The Eastern Corridor

MEETING #4 NOTES

Eastern Corridor Segments II and III

US 50 Corridor Focus Area

Extend Southbound Left Turn Lane at Walton Creek and US 50 Intersection

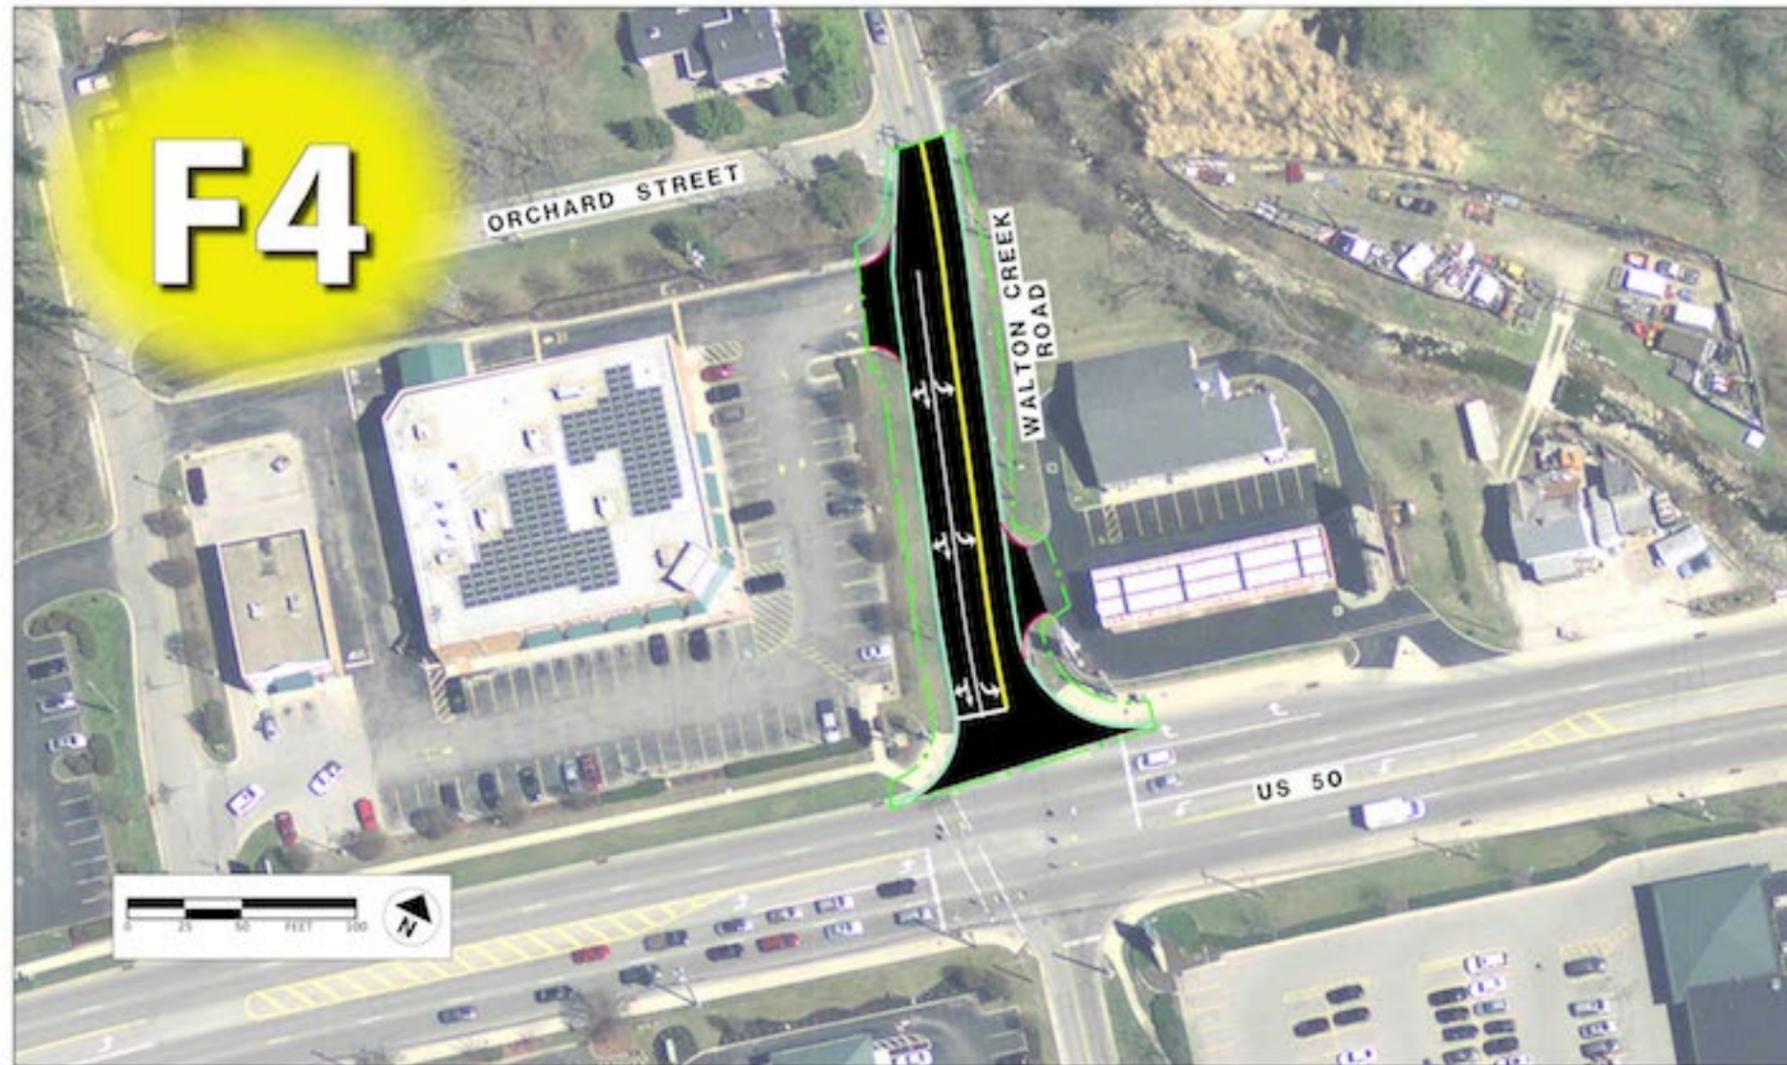
- Add protected/permissive southbound left turn phase at Walton Creek/US 50 intersection.
 - This would provide vehicles on Walton Creek turning left onto US 50 with a left turn arrow as part of the traffic signal cycle.
- Lengthen storage capacity for southbound turn lane.

- Consultant looked at the opportunity to realign Walton Creek Road on the north side of US 50. However, this would severely impact a business and is not recommended.
- ODOT is installing the five-section signal head soon. *[Post meeting note: this was completed in Sept. 2018.]*
- Existing turn lane storage capacity on Walton Creek is short; lengthening would provide better efficiency for left turns. Widening to accomplish this would occur on the Walgreen’s side of the road.

- Include this concept in the Implementation Plan as a low priority.

Roundabout at Newtown and US 50 Intersection

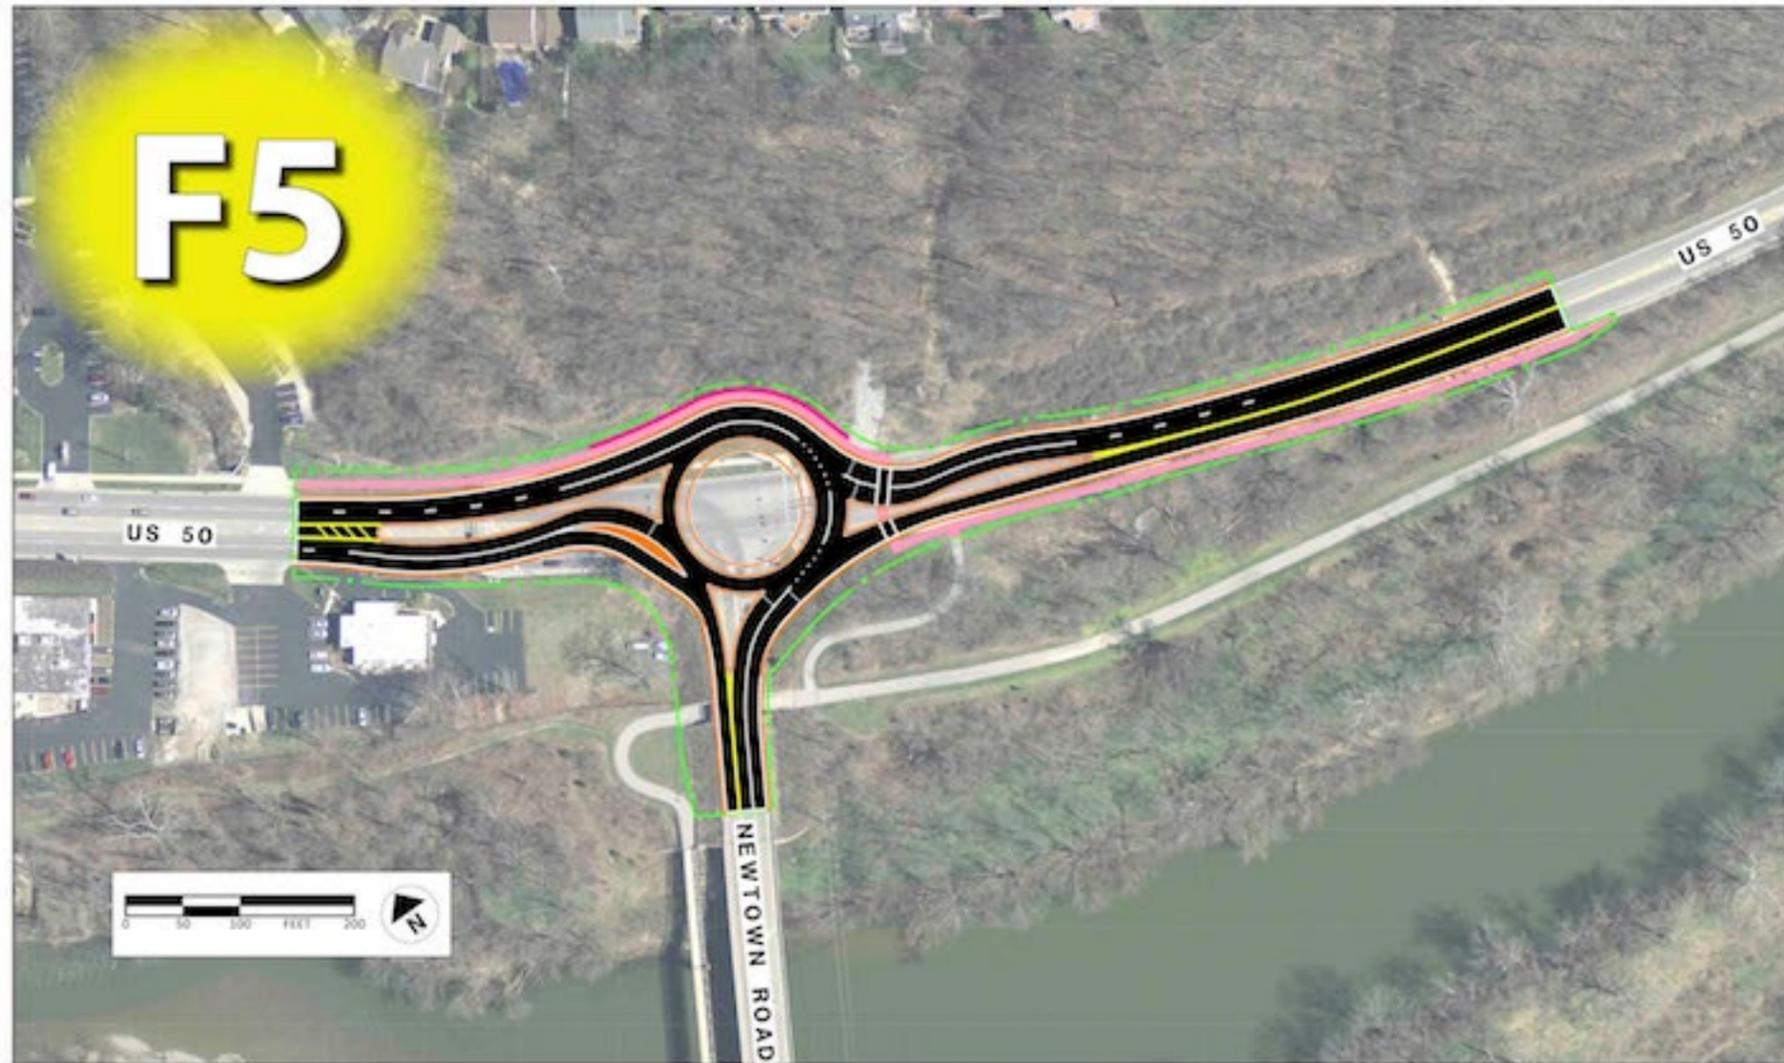
- Major traffic flow change will require community input. ODOT needs to verify Figure I-11c is drawn to scale and is sized to allow trucks and

- Simulations confirm nearly an 80 percent reduction of AM peak traffic delays and 50 percent reduction in PM peak traffic delays.
- Today, the current right turn from US 50 to Newtown Road is almost continuous and would not be changed.
- US 50 is four lanes in this point and can handle a constant stream of dual left turns from Newtown Road to US 50 generated by the roundabout.
- Roundabouts have the added benefit of calming traffic, providing easier access and improving safety in addition to serving as a gateway feature.
- The roundabout can accommodate fire trucks and semi trucks.

- Include concept in the Implementation Plan as a medium priority.

Shared-Use Path from Little Miami Trail to Spring Hill

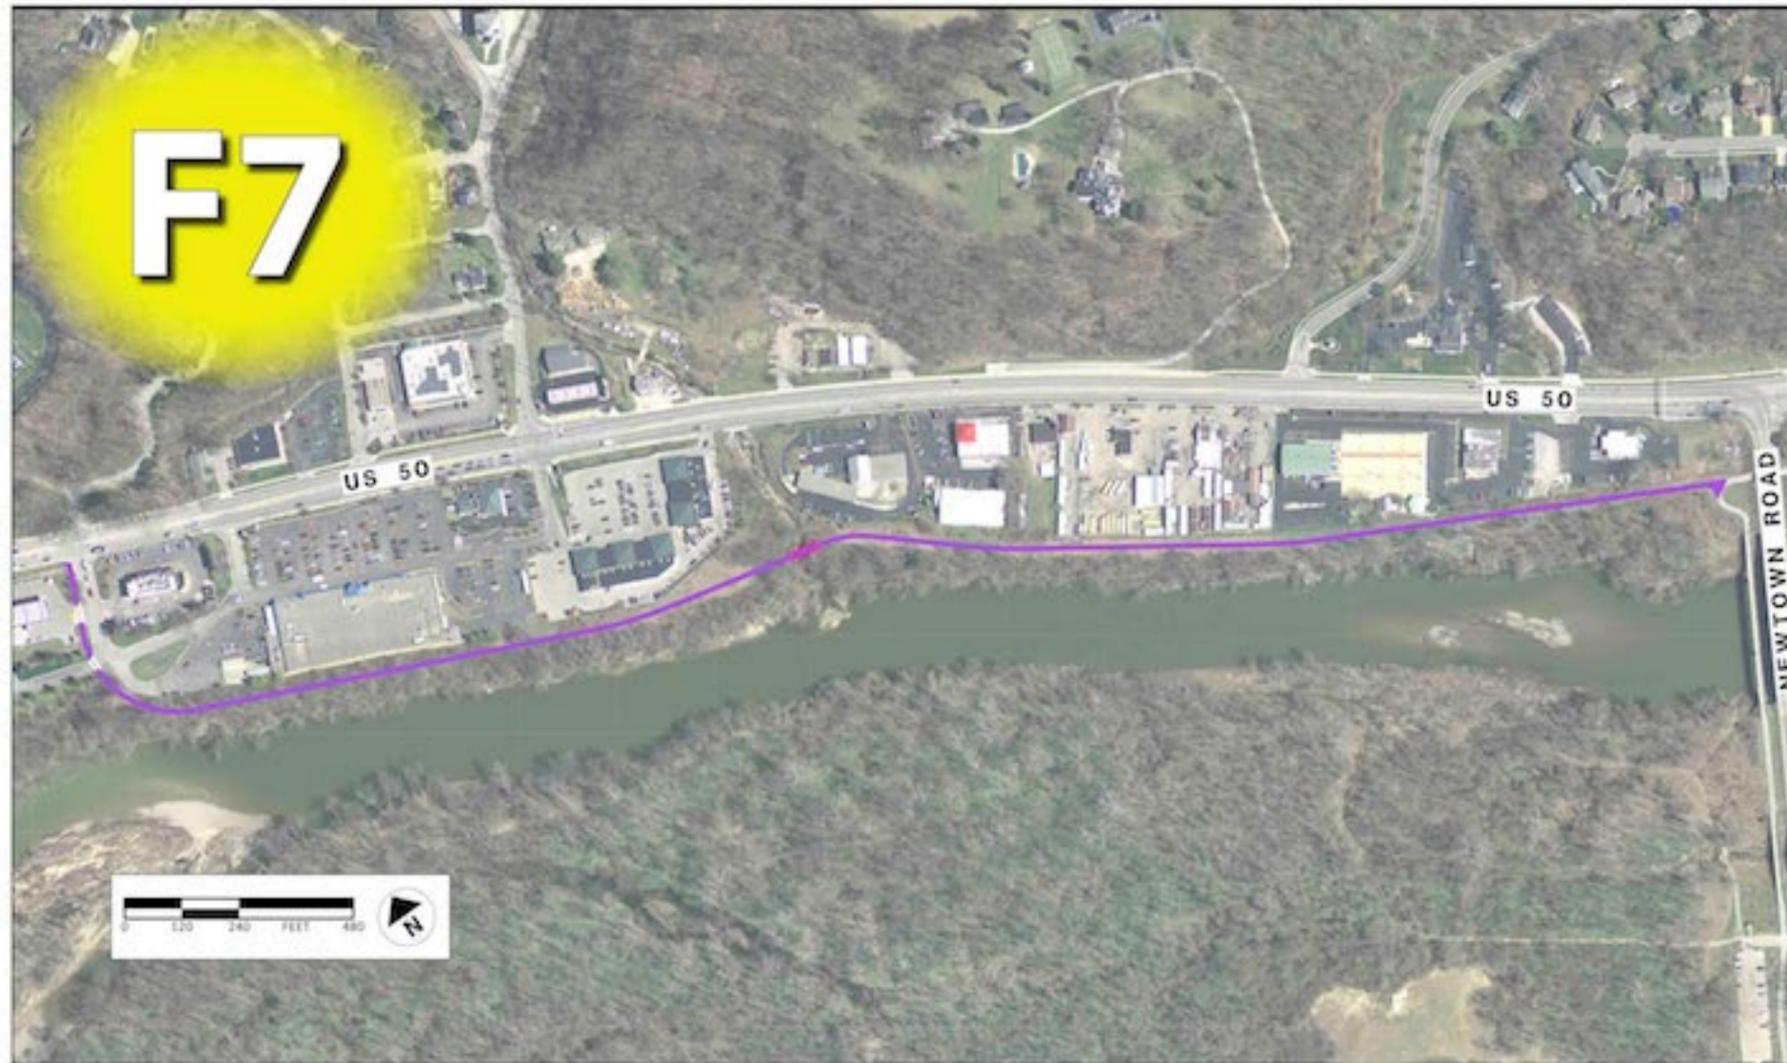
Great Parks of Hamilton County, Columbia Township and their consultant, IBI, are currently studying options to connect bicyclists and pedestrians with the Little Miami Trail. ODOT will wait until their study is completed to further develop concepts for bike/pedestrian connections within this portion of the US 50 Corridor. However, bike/pedestrian concepts suggested at the first Advisory Committee meeting were briefly reviewed in more detail with Great Parks and Columbia Township representatives and other Advisory Committee members during the May 18 meeting.

- ODOT has not provided information to Mariemont regarding proposed bike paths. US 50 focus area was only area where no bike plans were provided to date. Any proposed bike path(s) through Mariemont requires Mariemont approval.

- This concept received overwhelming support from the public - the highest for all concepts presented. See Public Feedback Ratings Summary, next page.
- There is still a plan to build a trail to 50 West in 2019. Great Parks of Hamilton County is currently requesting funding assistance from local businesses.

- Include this concept in the Implementation Plan as a high priority.
- This alternative is being advanced by Great Parks/Columbia Township.

Shared-Use Path Along US 50 from Spring Hill to Pocahontas

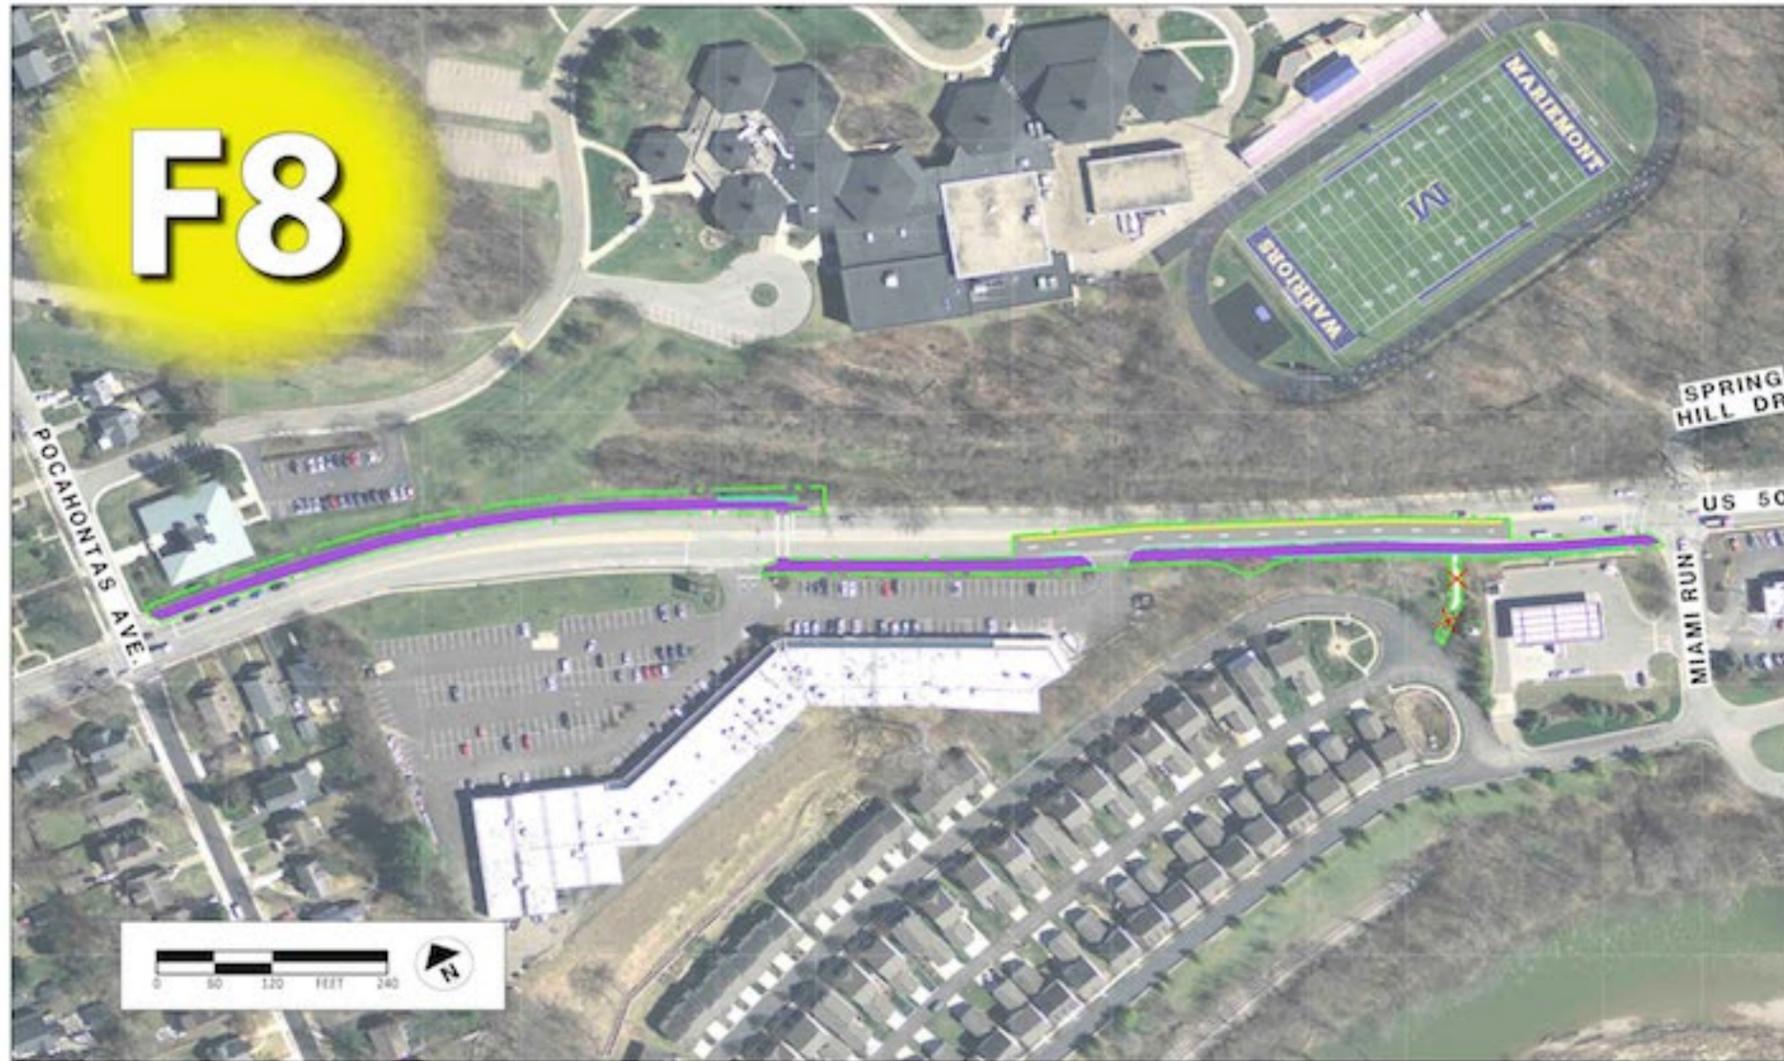
- There is a steep drop-off between the Mariemont Promenade and the Kroger gas station; if used as a bike path, the hillside would need to be stabilized with a retaining wall, making this concept expensive.
- A current project to replace a culvert at US 50 and Spring Hill will also widen the existing sidewalk here as much as possible at this time (to approx. 7 ft). Columbia Township would like this widening project to continue up the hill.

- ODOT has not provided information to Mariemont regarding proposed bike paths. US 50 focus area was only area where no bike plans were provided to date. Any proposed bike path(s) through Mariemont requires Mariemont approval.

- The stairway behind Kroger that currently connects to the Miami Run development (marked with a red “X” on the drawing) would be eliminated in this alternative. However, the shared-use path is minimally farther and more accessible/ADA compliant.

- Include concept in the Implementation Plan as a high priority.
